- "Response to NJDEP letter dated 08 May 2018, Site FTMM-53, Building 699, Former Gasoline Station, Remedial Investigation Report/Remedial Action Work Plan (RI/RAWP), Fort Monmouth, Oceanport, Monmouth County, New Jersey" (11 June 2018)

**SUBJECT: Site FTMM-53, Building 699, Former Gasoline Station
Remedial Investigation Report/Remedial Action Workplan (RIR/RAWP)
Fort Monmouth, Oceanport, Monmouth County, New Jersey
PI G000000032**

REFERENCE: NJDEP letter dated 8 May 2018, subject as above.

**FORMER UNDERGROUND STORAGE
TANK LOCATIONS AT FTMM-53**

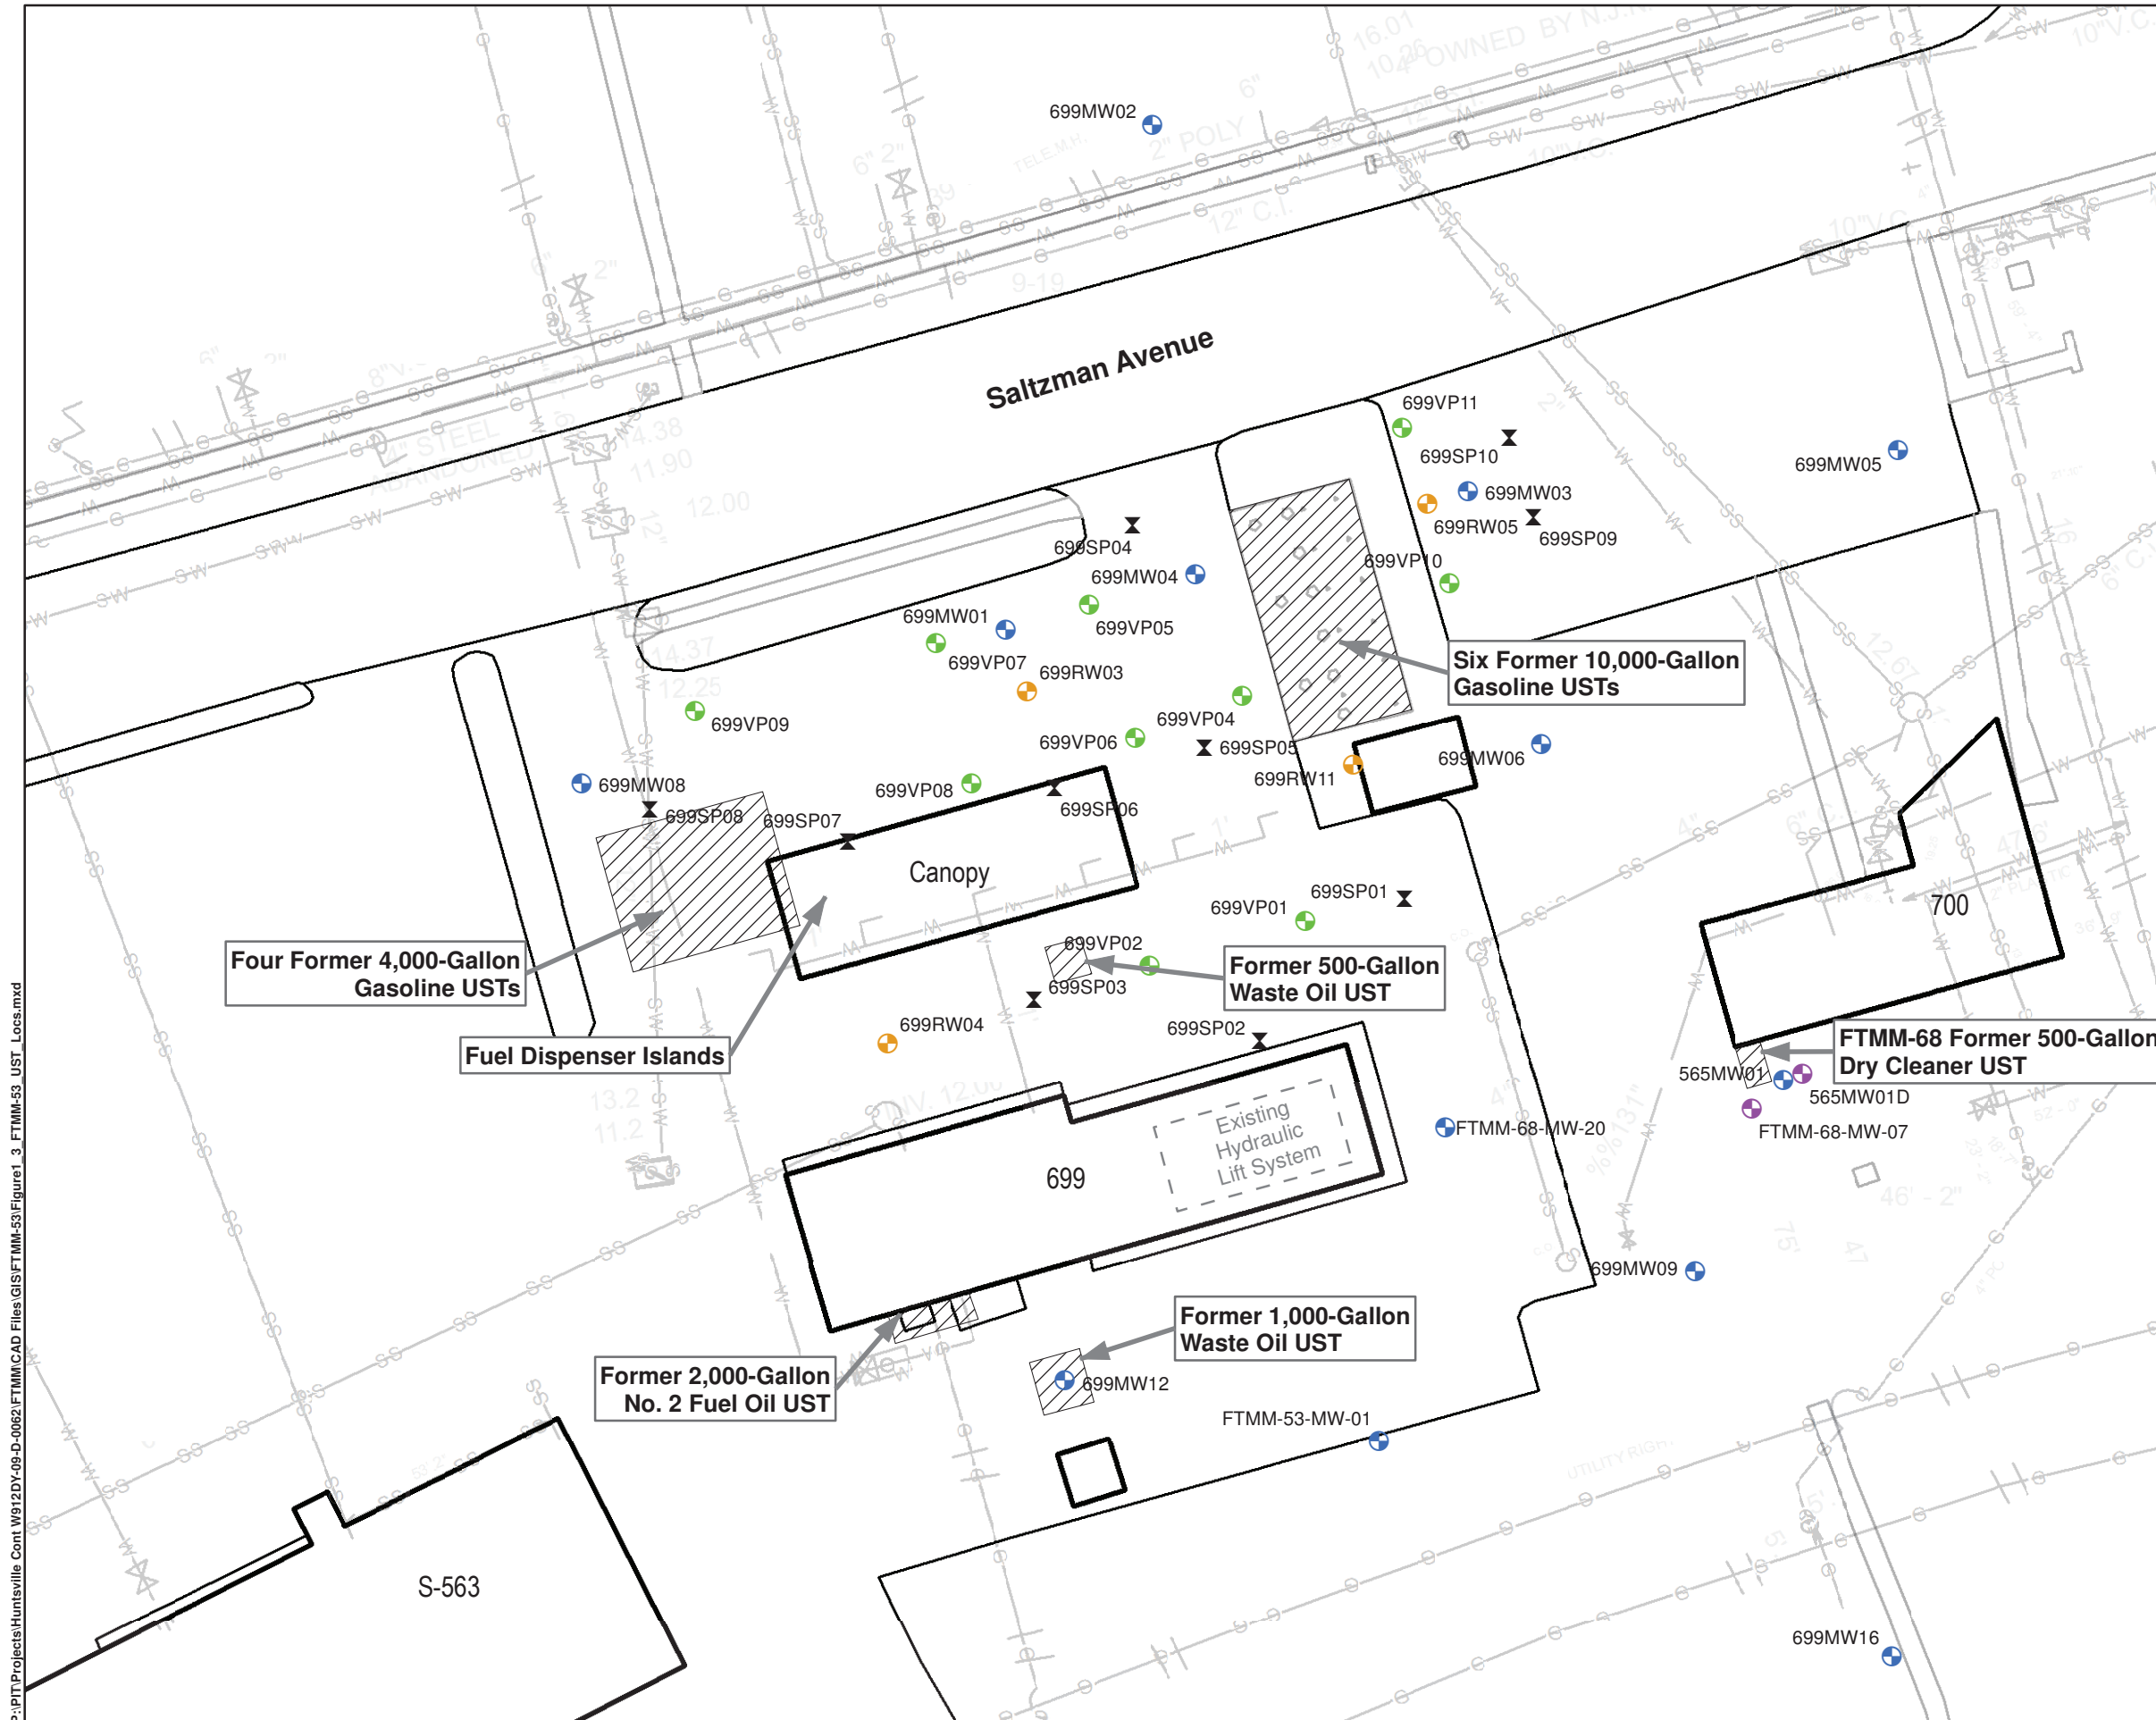
We have reviewed groundwater analytical data from downgradient well FTMM-68-MW-20 (please see attached figure). We have found that petroleum hydrocarbons indicative of hydraulic fluids were not detected in the 31 March 2017 sample from this well; this sample was analyzed for volatile organic compounds (VOCs), but not for semi-volatile organic compounds (SVOCs) as prescribed for hydraulic oil in Table 2-1 of the NJAC 7:26E *Technical Requirements for Site Remediation*.

To avoid a release in the future, the Army will remove the hydraulic fluid from each of the five lifts by pumping. Within 1 to 2 months following the oil removal, the lifts will be re-inspected to determine if groundwater has infiltrated into the hydraulic cylinders. In addition, during our next round of groundwater sampling (tentatively planned for August 2018) we will collect a groundwater sample from downgradient well FTMM-68-MW-20. The sample will be analyzed for VOCs and SVOCs to identify if a hydraulic fluid release from Building 699 has impacted groundwater.
